Regulatory Division  
POA-1994-01014-M1

**DEPARTMENT OF THE ARMY**  
**PERMIT MODIFICATION**

Department of the Army permit (DA) number POA-1994-01014-M1, Orca Inlet, was issued to The Native Village of Eyak on October 16, 2017, to construct the Cordova Oil Spill Response Facility (COSRF) which included the following components:

This is the 1st modification of the original permit. The permit is hereby modified as follows:

NEW SMALL BOAT RAMP STRUCTURE  
PLAN & SECTION

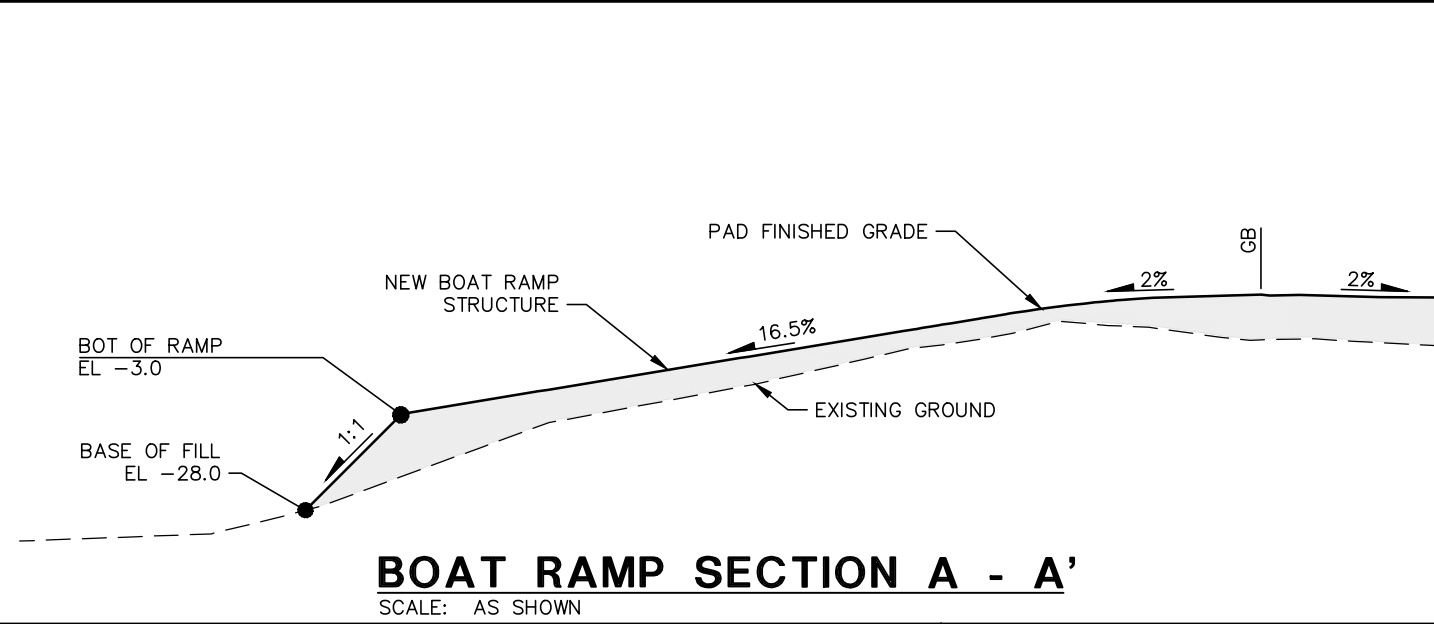
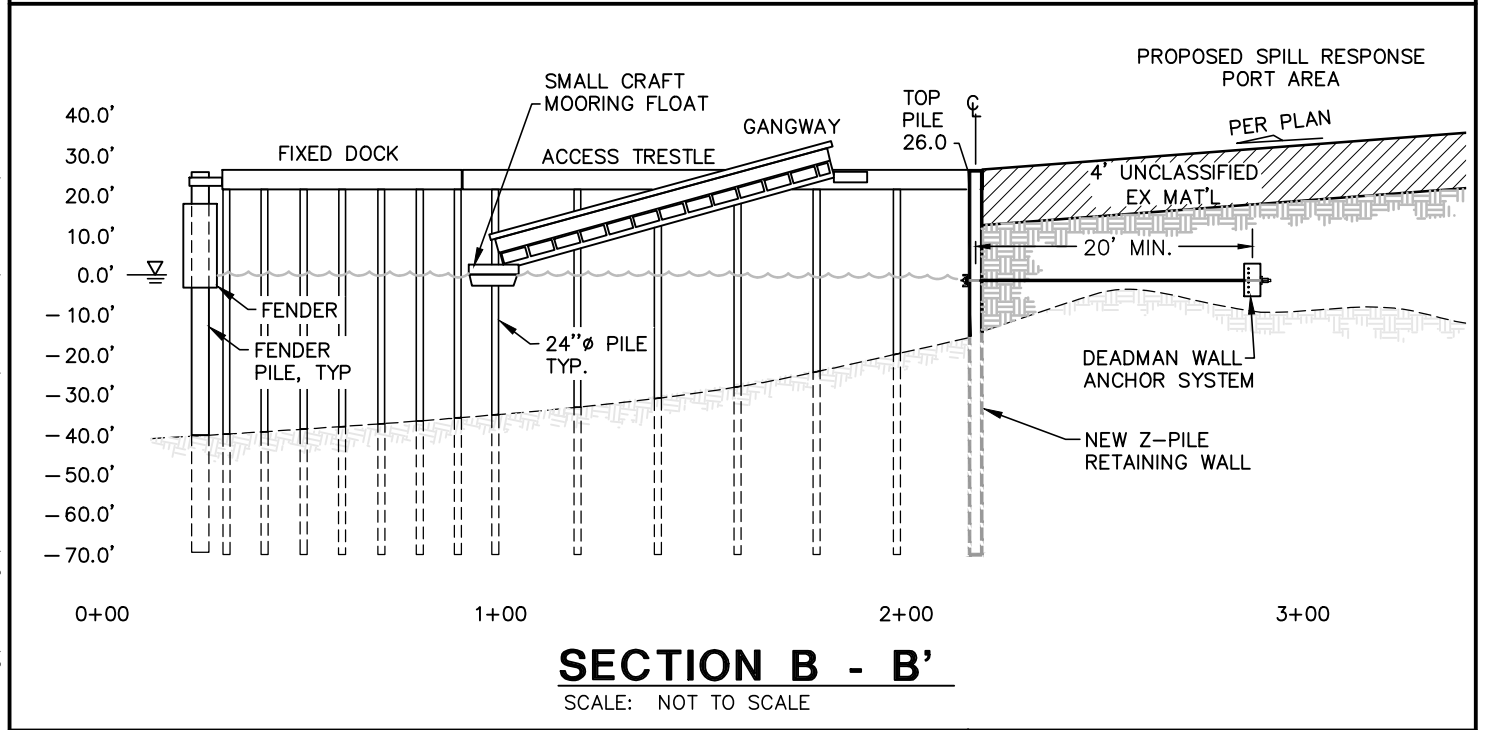
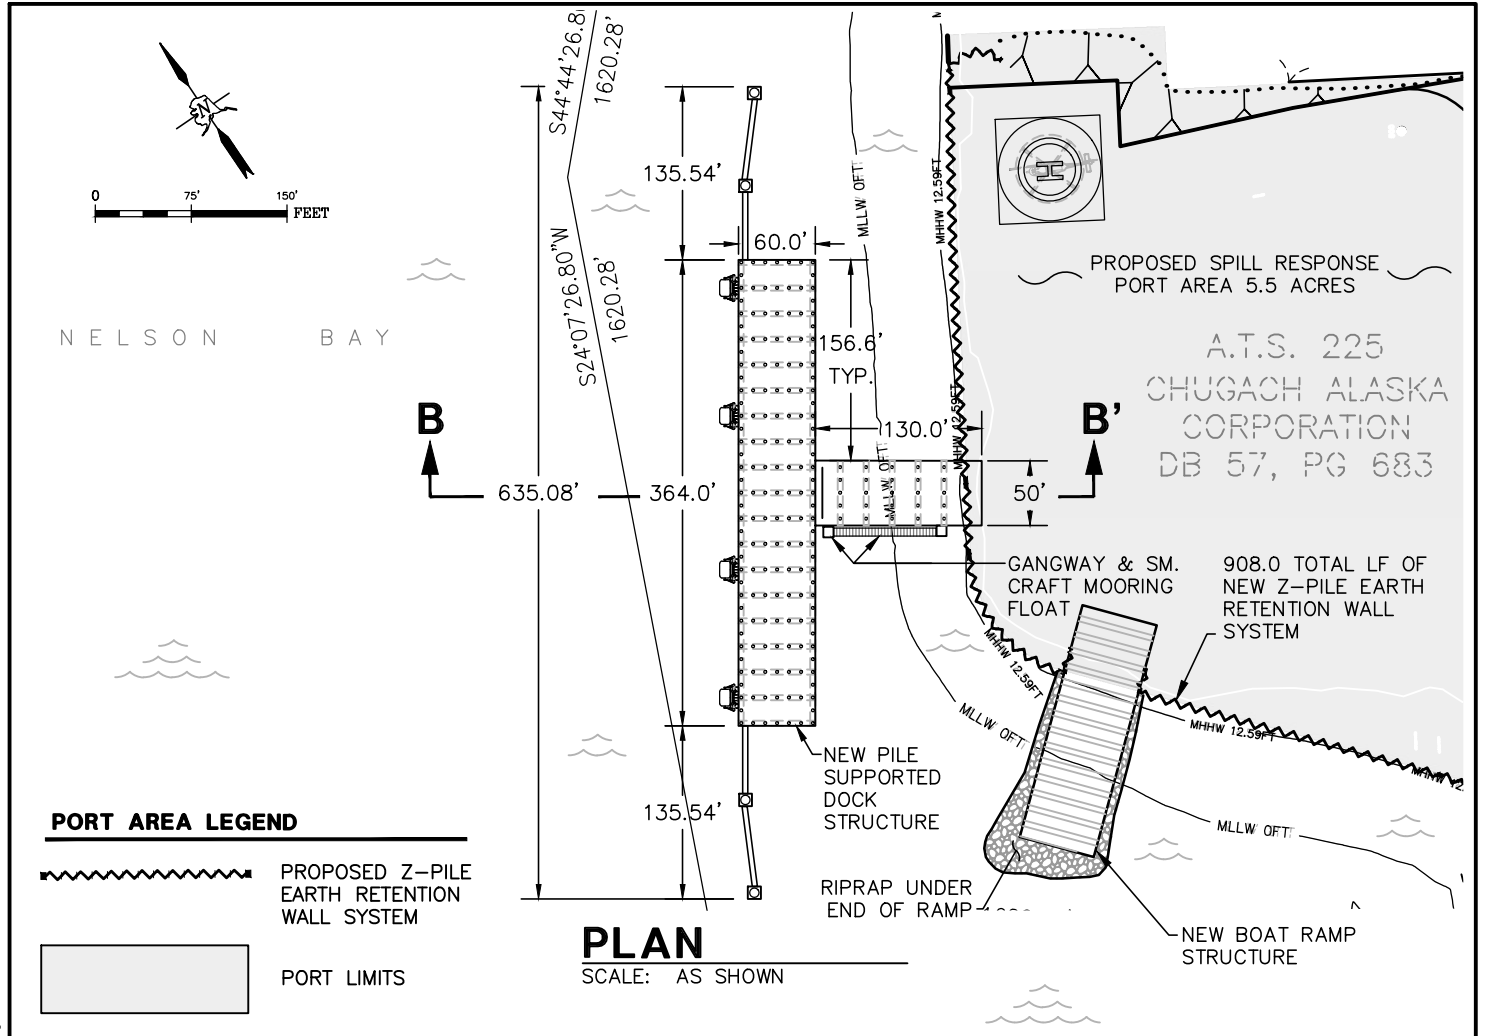
6) Modify Boat ramp configuration from 200-foot by 35-foot boat ramp authorized by the 2017 DA permit to 187.5-foot by 60-foot boat ramp at the Shepard Point pad and staging area.

THIS SHEET  
HUMPBACK CREEK BRIDGE PLAN & PROFILE

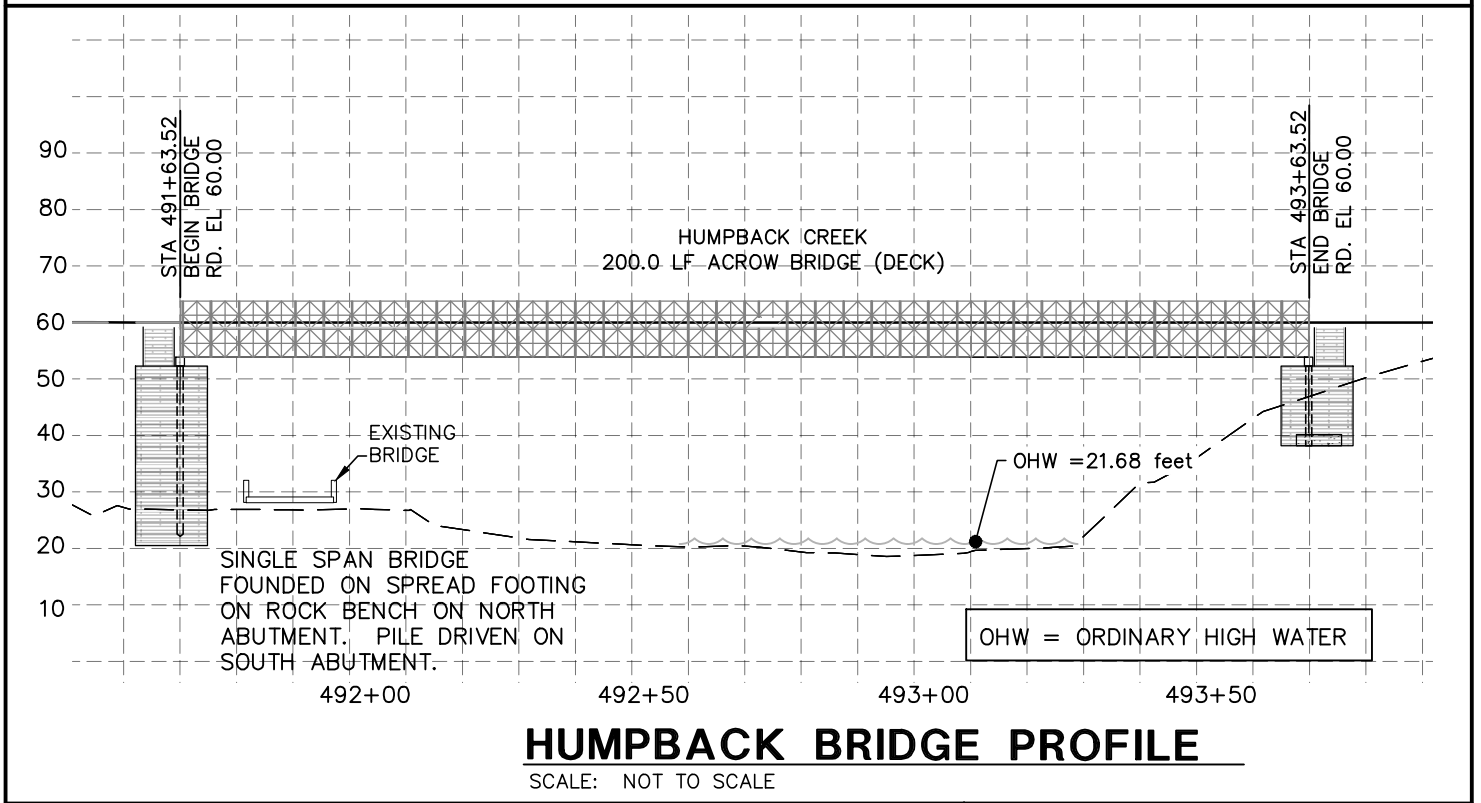
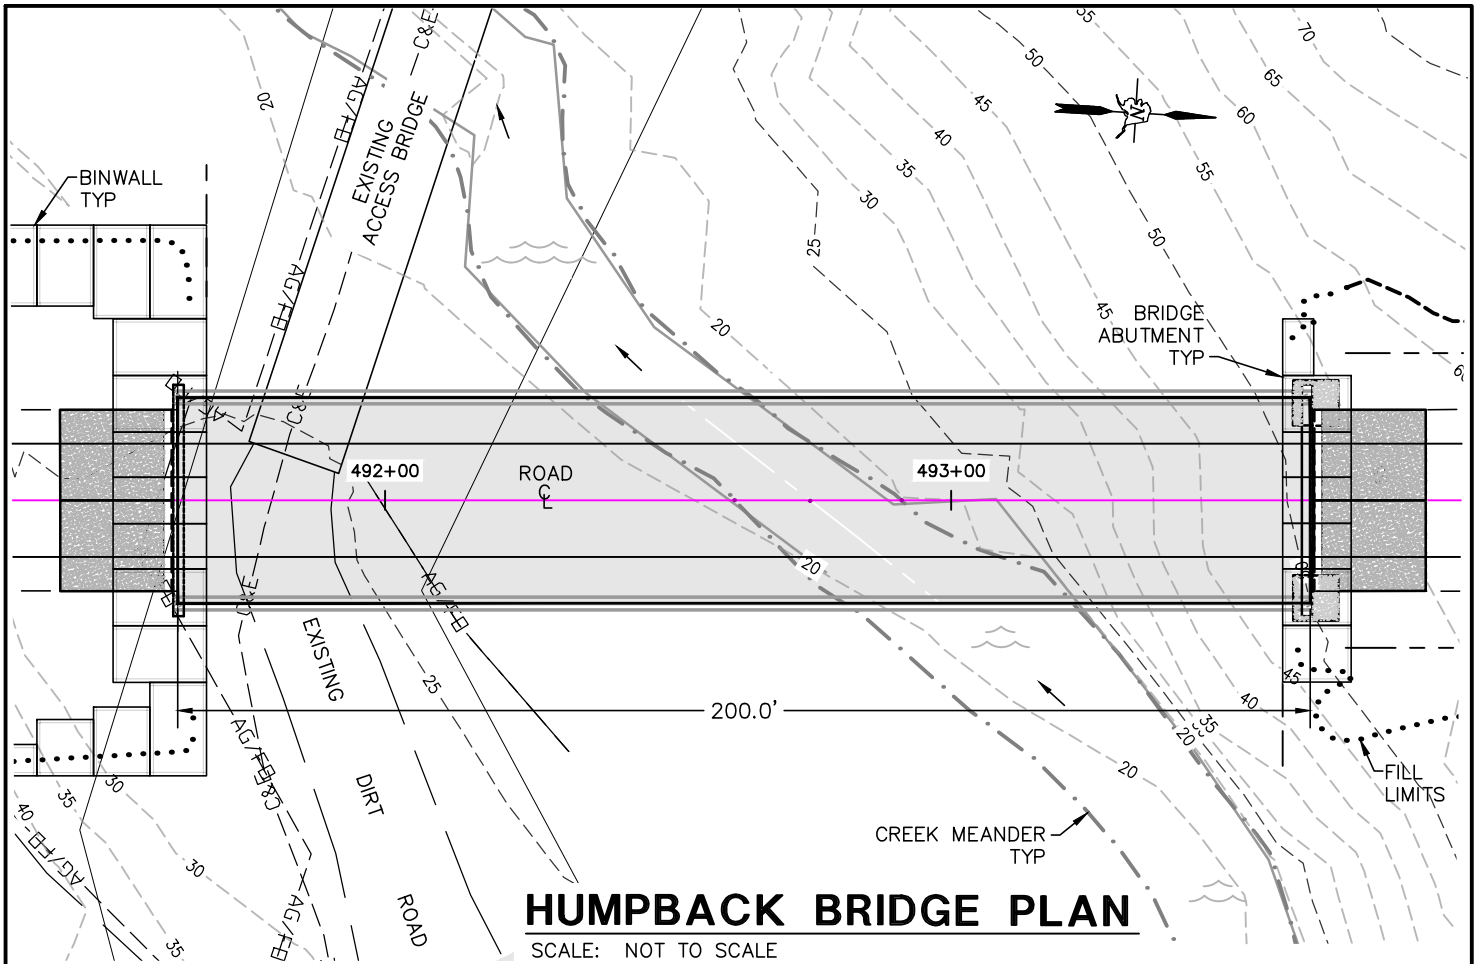
1) Modify road alignment near Humpback Creek: Adjust the road alignment to go around Humpback Mountain to the west rather than the east to avoid potential impacts on the Cordova Electric Cooperative (CEC) penstock tunnel. The realigned road will cross Humpback Creek via a 200-foot clear span bridge downstream of the CEC powerhouse tailrace.

3) Construct a modular, prefabricated steel truss bridges at No-name Creek and change the Orca Creek stream crossing to a culvert. Bridges over Little Humpback Creek and Humpback Creek shown on the 2017 DA permit plans would be changed to modular, prefabricated steel truss bridges and moved to the new crossing locations for the new road alignment.
